Technical Bulletin

E-Series Sideshifter Lower Hook Installation, Adjustment and Torque Check

SS0116.ill

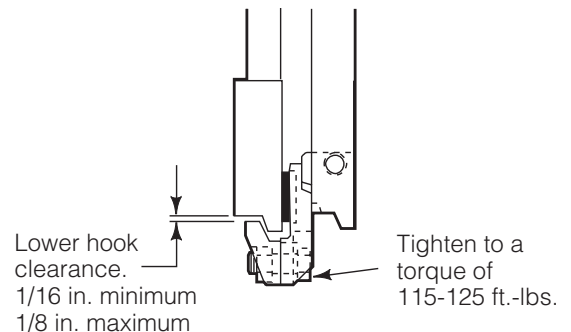
- 1 Adjust the lower hooks up tight to the truck carriage bar, then back off one rib position. The clearance between the hook and truck carriage bar should be 1/16 in. minimum to 1/8 in. maximum. Tighten the capscrews finger tight.
- 2 Tighten the capscrews to a final torque of 115-125 ft.-lbs. with a manual torque wrench.

Replace all Type A nuts with Type B nuts.

WARNING: Improper installation, adjustment and over or under torquing of the lower hook capscrews may result in the sideshifter disengaging from the truck carriage possibly causing serious injury or property damage. Check the capscrews torque every 500 hours.
